## IDAP REPORT

<b>Property:</b>	46 Long Street STRATHFIELD Lot: 109 DP: 746 DA2022.29
<b>Proposal:</b>	Demolition of existing structures and construction of a two (2) storey dwelling with basement, swimming pool and outbuilding.
<b>Applicant:</b>	BluPrint Design
<b>Owner:</b>	Wewood Development Pty Ltd
<b>Date of lodgement:</b>	16 February 2022
<b>Notification period:</b>	2 March 2022 - 16 March 2022
<b>Submissions received:</b>	Nil
<b>Assessment officer:</b>	L Gibson
<b>Estimated cost of works:</b>	\$1,597,162.00
<b>Zoning:</b>	R2-Low Density Residential - SLEP 2012
<b>Heritage:</b>	N/A
<b>Flood affected:</b>	Yes
<b>RECOMMENDATION OF OFFICER:</b>	<b>APPROVAL</b>

Figure 13: Original design featuring skillion roof angled up to the façade

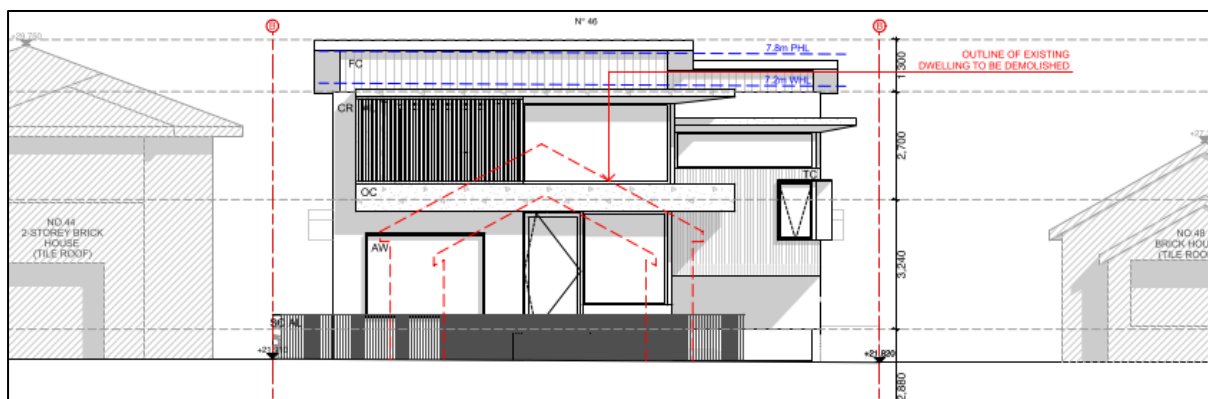
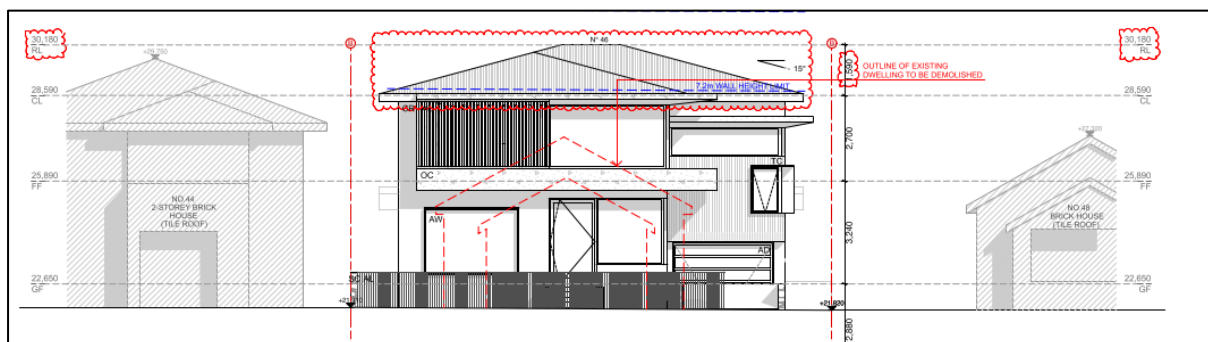
The proposal has been revised throughout the assessment process to achieve a more acceptable design which is more commensurate with existing and anticipated future development in the streetscape. Figures 13 – 16 below demonstrate the proposed façade changes which have resolved to delete the skillion roof angled to the façade and replace with a pitched roof form. The proposal has also incorporated a false garage door at the basement entrance so to better integrate with existing dwellings in the streetscape which comprise predominantly of at-grade parking.

The proposal is well articulated seeking a varied front setback with varying heights and a modulated built form. This assists in reducing the apparent bulk and height of the dwelling as viewed in the streetscape. This is of particular importance given the dwelling's requirement to artificially raised floor levels to address the flood affectation of the site.

Figure 14: Revised and current proposal seeking pitched roof form

Figure 17: Ground floor level showing close proximity of alfresco.

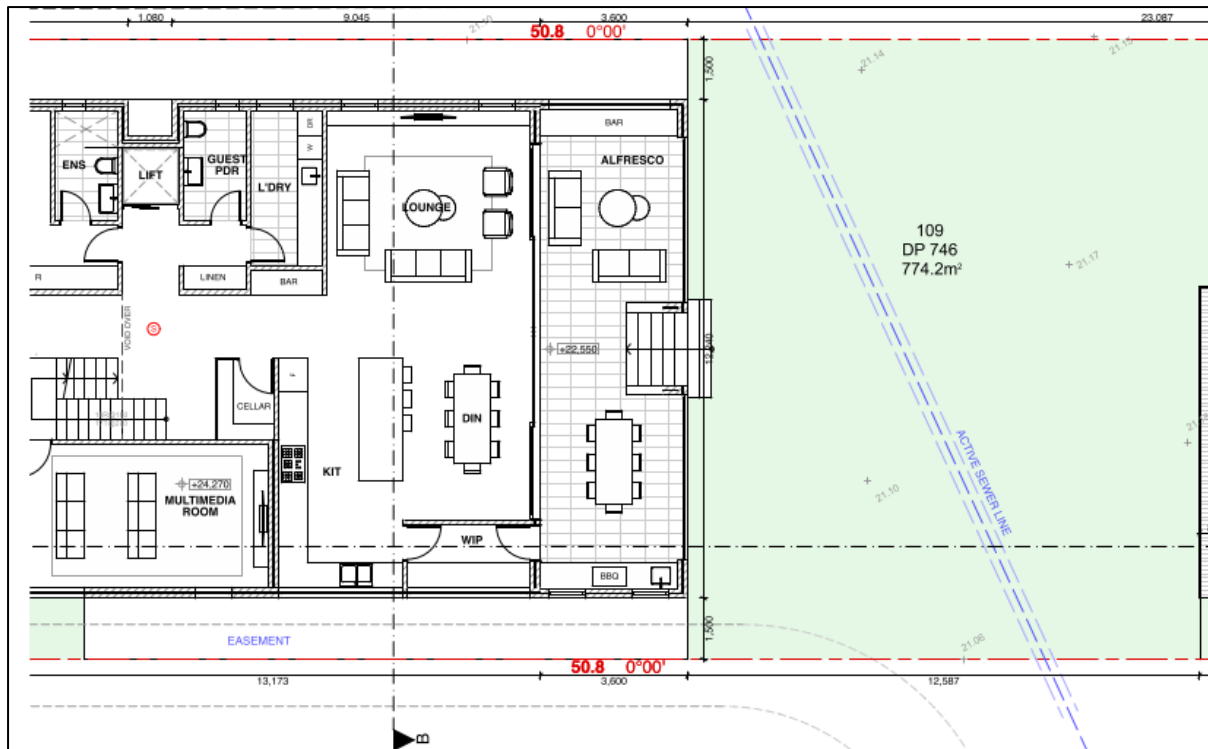
Due to the heavy flood affectation of the land, the ground floor level has been required to be designed to a minimum freeboard of RL 22.650. This has resulted in the rear alfresco area protruding 1.48 above NGL to a height of RL 22.550. The alfresco area does not constitute habitable floor area when designing a freeboard for flood affected properties. The level of the alfresco can be less than the minimum freeboard so long as it is not less than the 1 in 100 year ARI flood level. Accordingly, the alfresco is recommended to be reduced in height by 450mm from RL 22.550 to RL 22.10. This will ensure that the alfresco area align more closely toward the ground.

Notwithstanding this condition, the alfresco will still be raised considerably above natural ground level. Accordingly, a condition of consent is recommended requiring the louvers to the eastern and western side boundaries to be permanently fixed so as not to result in any overlooking impacts to the eastern and western adjoining neighbours.

Figure 19: Original basement floor plan

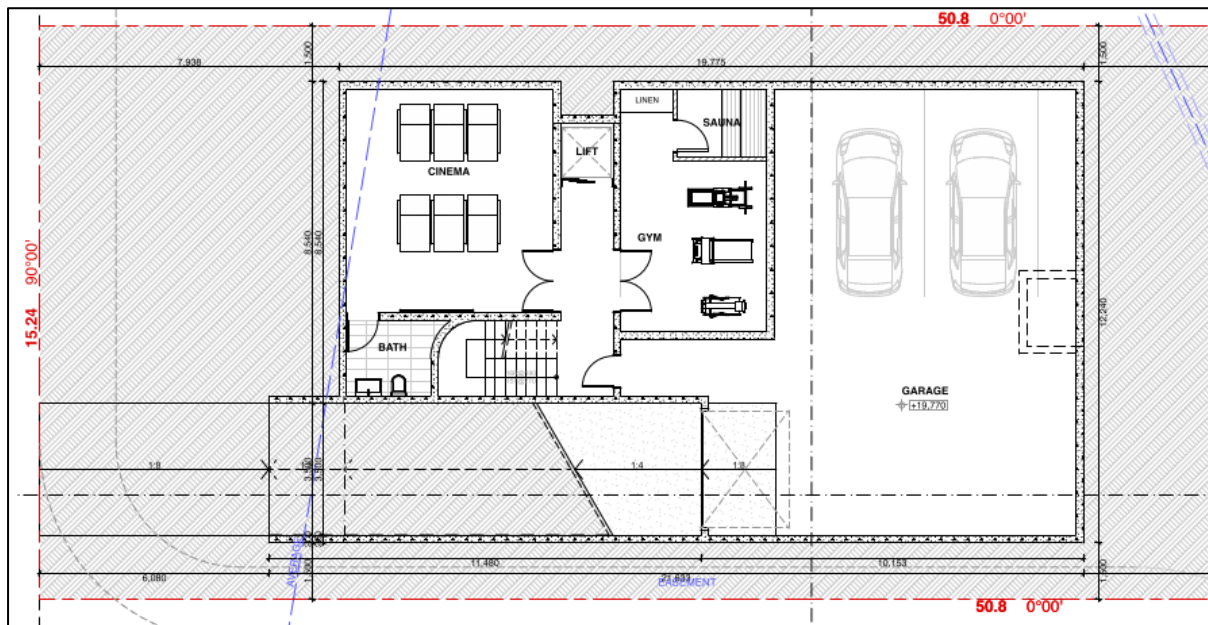
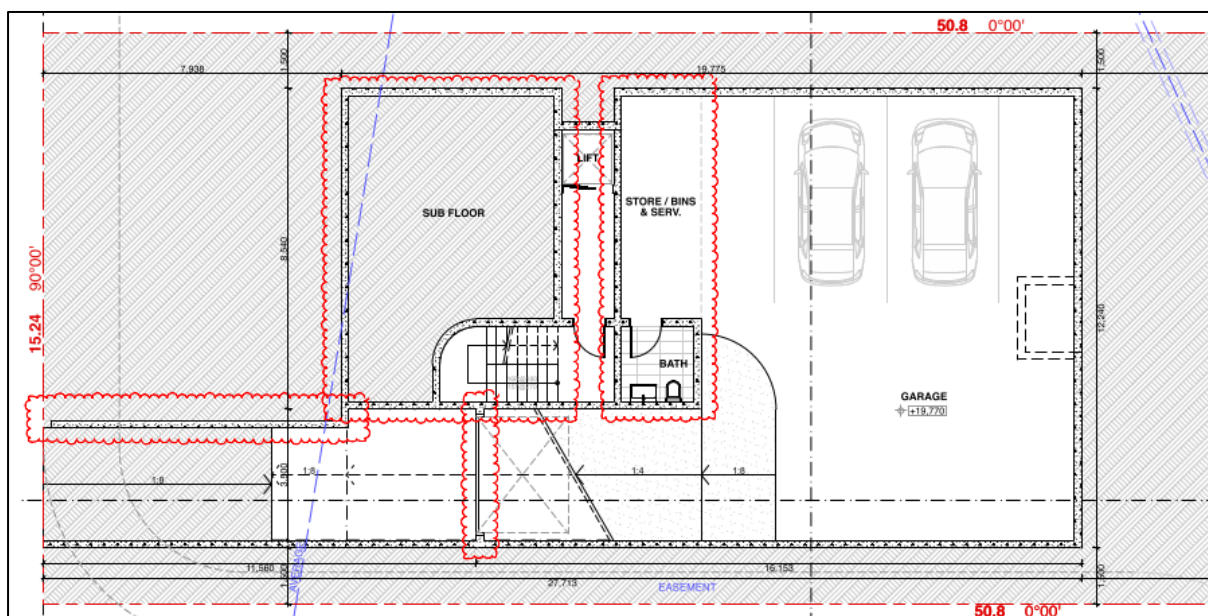
Due to the heavily flood affected nature of the site, the basement results in a maximum protrusion of 1.49m above NGL. This is contrary to Council's DCP controls requiring the basement not to exceed 1m above NGL. The submitted Flood Impact Study requires a minimum freeboard of RL 22.65 to be provided for habitable floor areas so to achieve 500mm above the 1 in 100 year flood level. If a basement were not proposed for the site, the dwelling would still be required to achieve a minimum floor height of RL22.65 thus being 1.49m above NGL. Given the location of the active sewer line traversing the site and the requirement for the floor levels to be raised substantially above the ground, it is considered appropriate in this instance that the development utilise this opportunity to provide a basement within this space.

The basement is generally confined to the ground floor footprint with the exception of the rear portion pertaining to the alfresco area. This is considered appropriate given that the basement must be extended this far beyond the front property boundary so to achieve the minimum gradient and crest height required for the site.

The proposed basement footprint has been revised throughout the assessment process (refer to Figures 19 and 20 below). Overall, the basement footprint has been reduced resulting in the deletion of the cinema, gym and sauna. This has reduced the overall floor space of the dwelling as well as ensuring all habitable rooms are now above the freeboard required for the site so as not to pose a flood risk to residents.

It is noted that there is no opening provided between the lift well/ stair area to the parking area within the basement. Accordingly, a condition of consent is recommended that an opening is provided so that access can be maintained between the stairwell / lift well and parking area of the basement.

Amendments made in red on approved plans	All changes made in red on the approved plans shall be updated and shown on the Construction Certificate plans.
Basement Access	An opening is to be provided between the stairwell and lift well area to the parking area of the basement so to enable residents to access the parking area internal to the building.
Basement subfloor	The basement subfloor shall be deleted from the design plans so as not to be misconstrued as basement footprint.
Privacy Screen	The privacy louvres both to the western and eastern side elevation of the alfresco shall be fixed in a position that does not allow downward viewing of the adjoining properties.
